**RE: Annual Update to Financial Surety, License SUA-1341**

**COGEMA Mining, Inc.**  
**Year 2000 to 2001**  
**Decommissioning and Reclamation Cost Estimate Update**  
**Irigaray and Christensen Ranch Projects**  
**NRC License SUA-1341**

**RE: Irigaray-Christensen Operations, Permit No. 478, Review of 1999  
Semiannual and Annual Reports**

**MEMORANDUM**

DM10

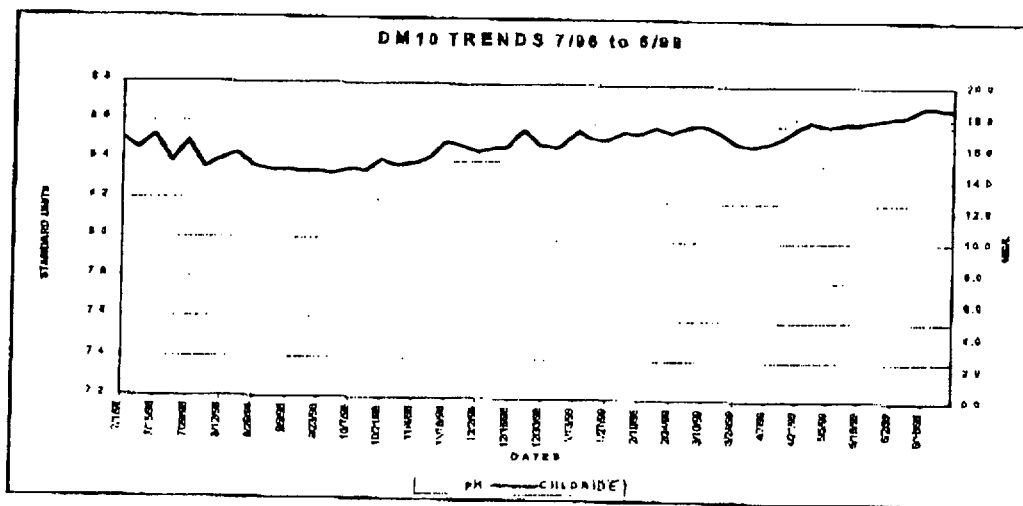
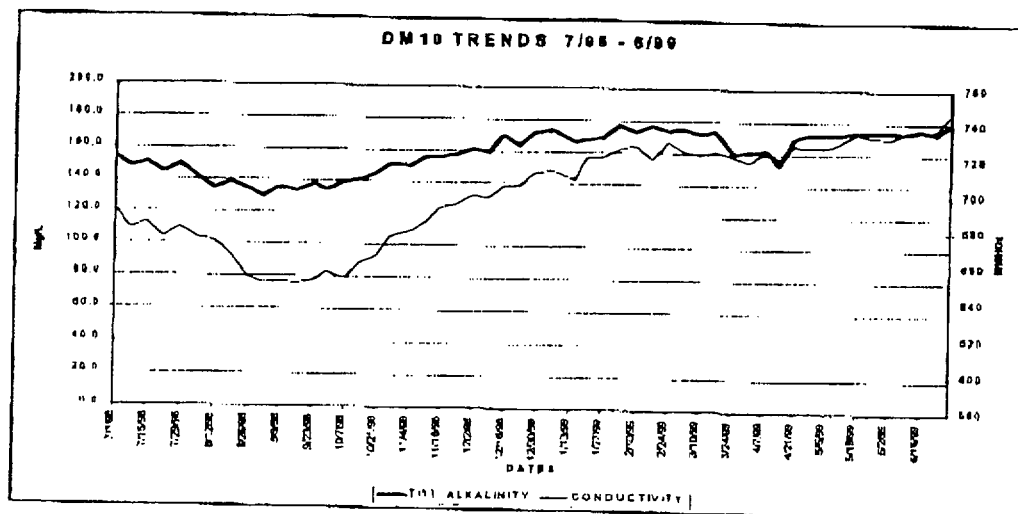
Trends visible over the year in this deep monitor well at Irigaray are a gradual and slight increase in chloride levels along with fluctuation in pH levels over the year that resulting in no net change for the year.

For conductivity and total alkalinity trends over the year, these mirror the chloride levels by a overall gradual increase over the report year.

**SSM3**

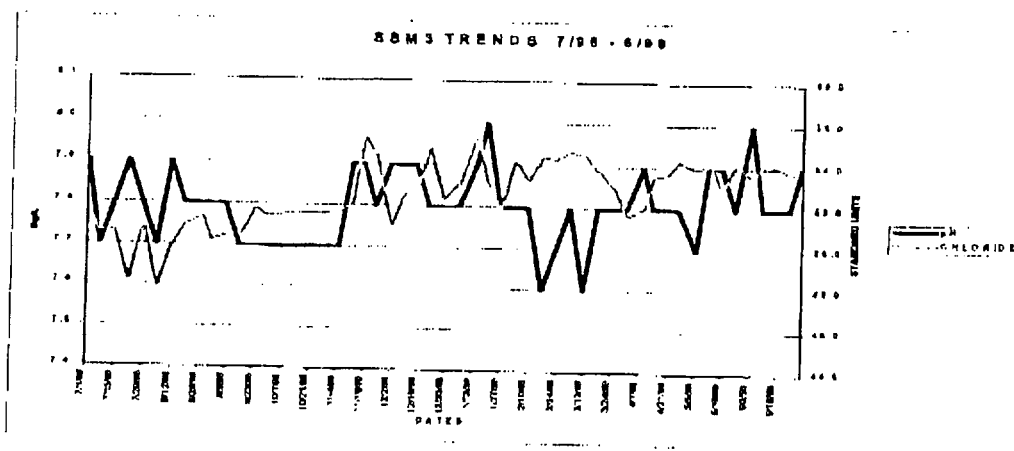
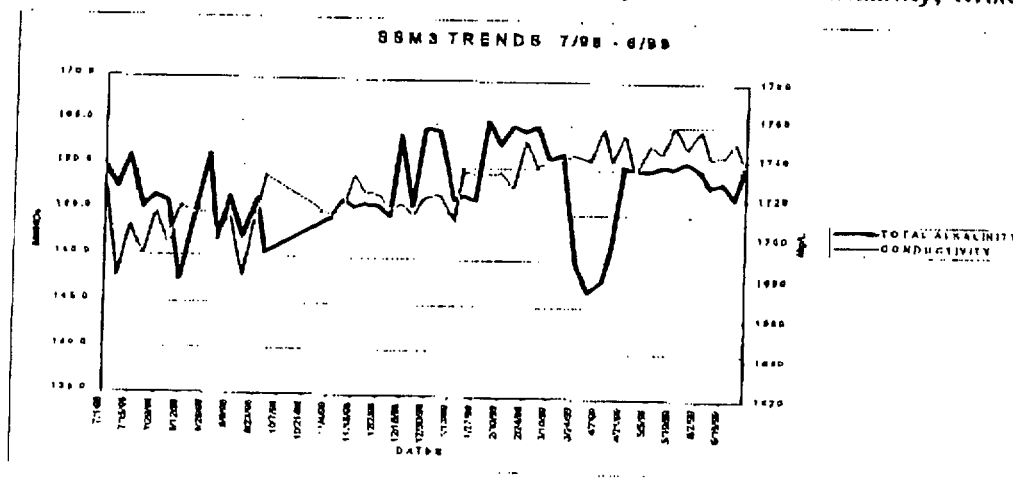
Chloride and ph for SSM3, located in Irigaray Unit 2, trended upward through the report year.

Conductivity also trended upward through the year but total alkalinity, while showing

some fluctuations, ended up nearly unchanged for the report year.

**SSM18**

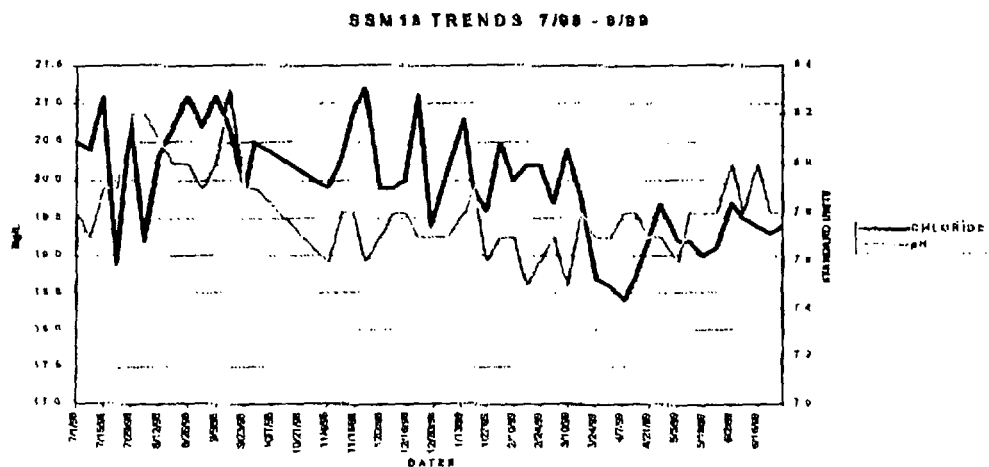
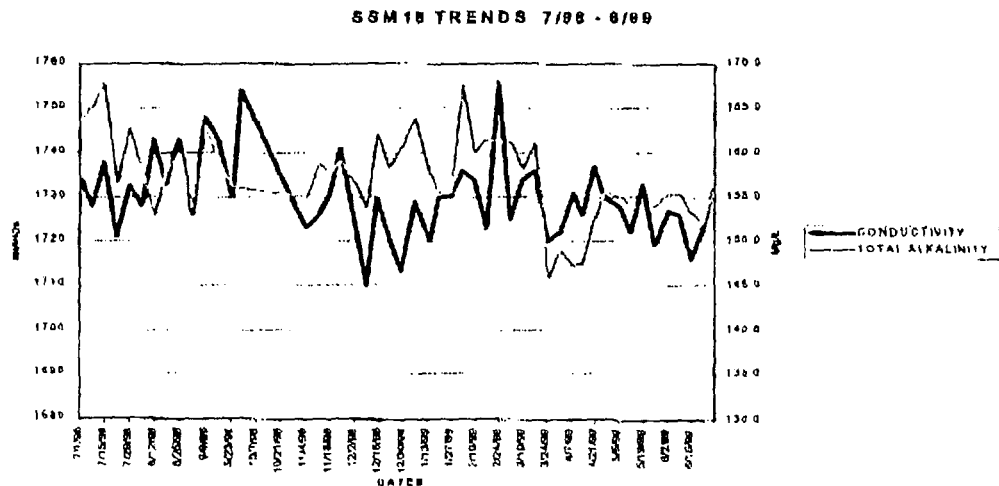
The trends for SSM18, an Irigaray Unit 8 shallow sand monitor well bucked the trends for nearly all other Irigaray shallow sand monitor wells. Chloride and pH levels were down, pH only slightly.

The trends for conductivity and total alkalinity for SSM18 were also down for the report year, with a greater decrease for total alkalinity.

**SSM40**

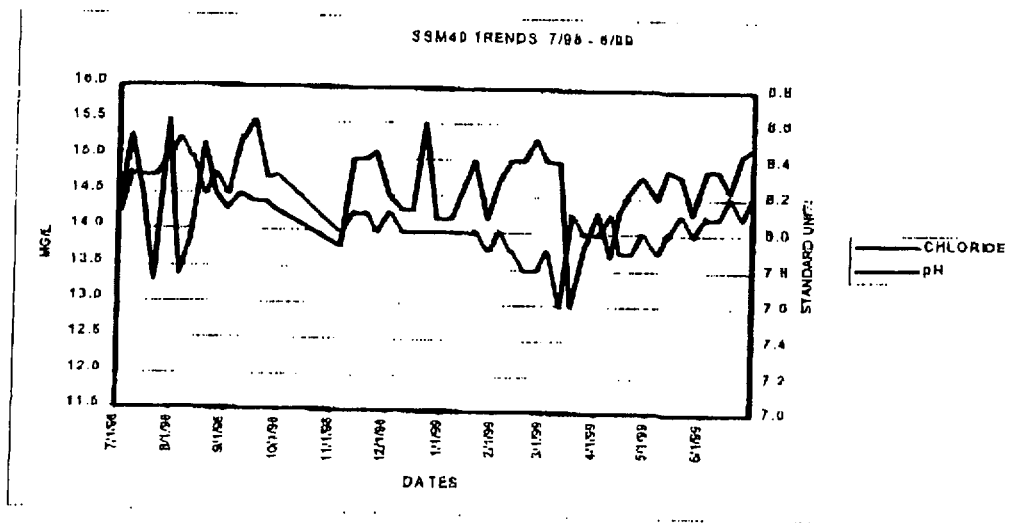
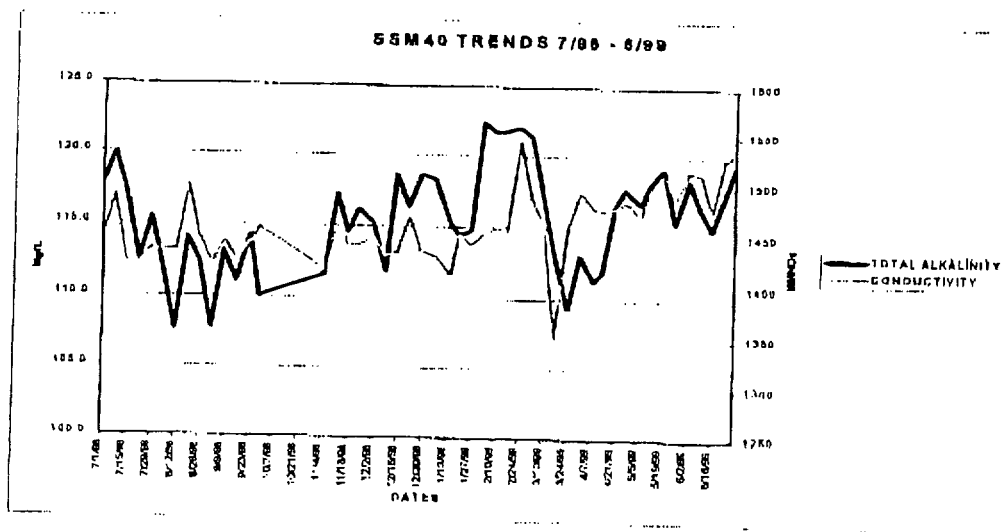
This shallow sand monitor well in Irigaray Unit 8 showed relatively wide variations throughout the report year, but ended with little changes for either pH or chloride.

Conductivity and total alkalinity also varied throughout the report year, but only a slight gain for conductivity was recorded and none for total alkalinity.

SSM41

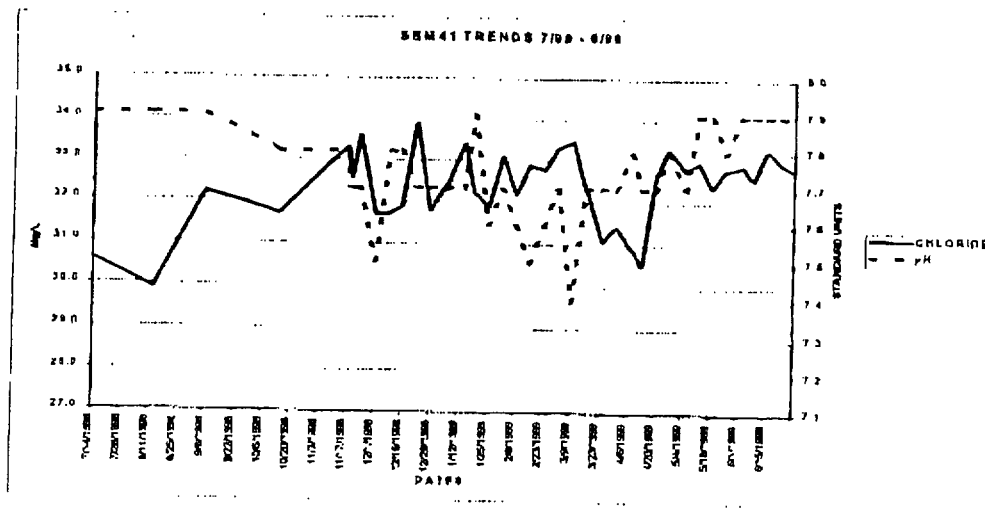
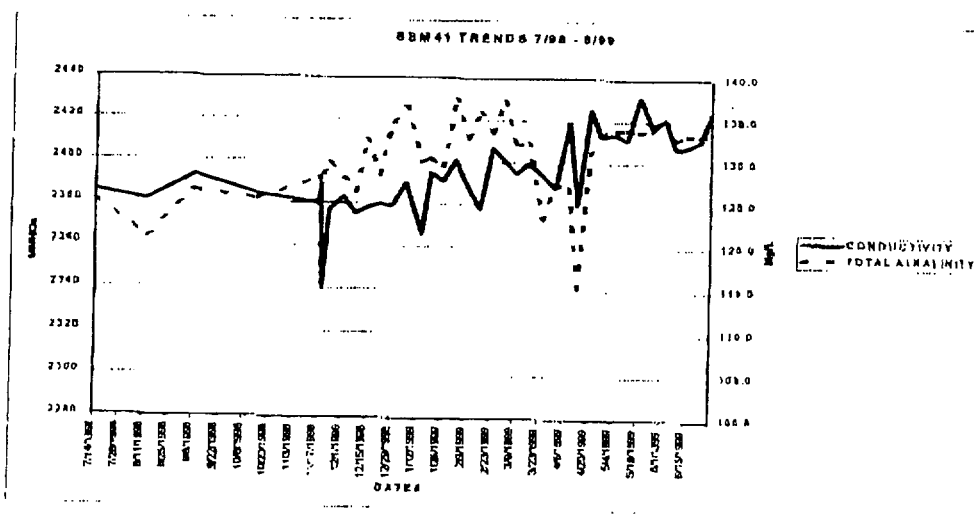
For SSM41, a shallow sand monitor well in Unit 4 at Irigaray, chloride trended upward through the report year but pH, while varying during the year, ended unchanged.

Conductivity at SSM41 also moved upward through the year as did total alkalinity.

SSM42

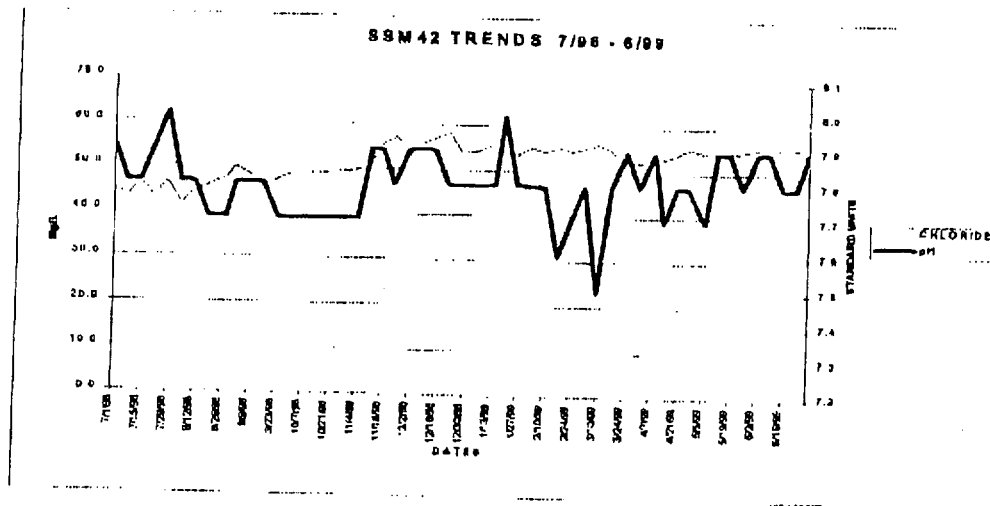
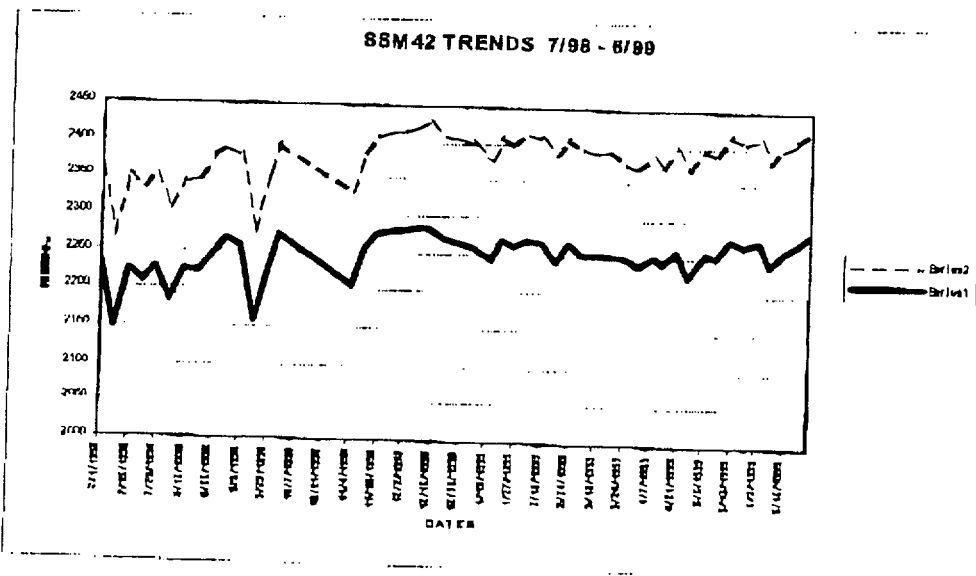
For SSM42, a Unit 3 shallow sand monitor well at Irigaray, only a small upward trend for chloride is apparent, while pH moved through a small range with no trend readily apparent.

Conductivity and total alkalinity also trended upward in SSM42, a move more apparent for conductivity.

**SSM43**

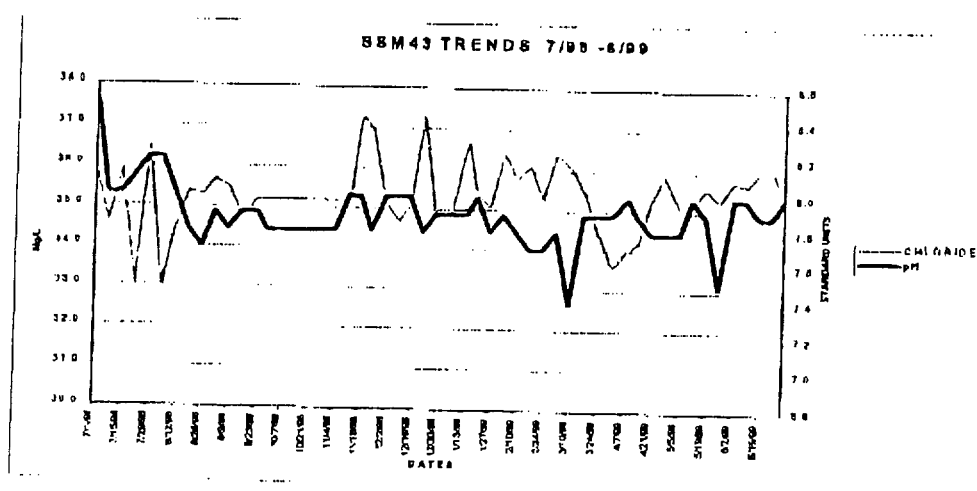
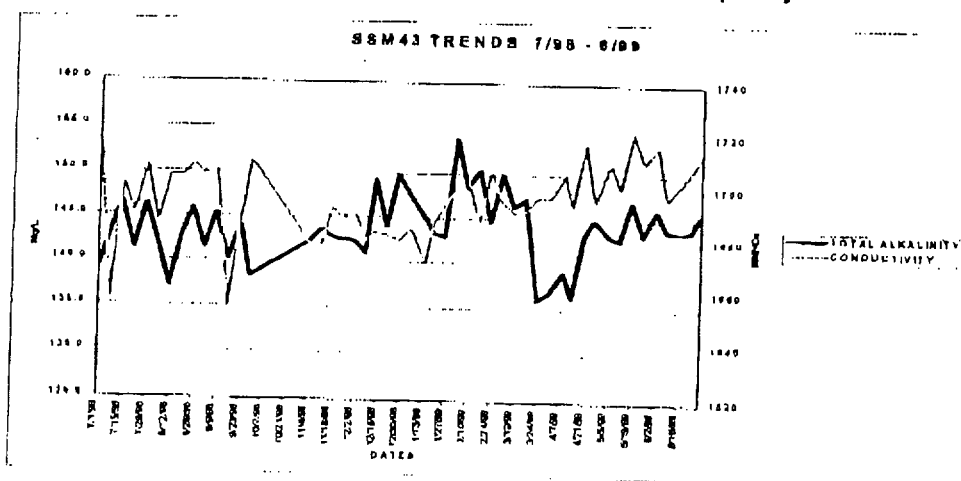
While some variation was noted for chloride and pH in SSM43, an Irigaray Unit 1 shallow sand monitor well, no trend was obvious for either parameter.

For total alkalinity, the lack of an apparent trend is also true, but conductivity seem to have moved upward throughout the second half of the report year.
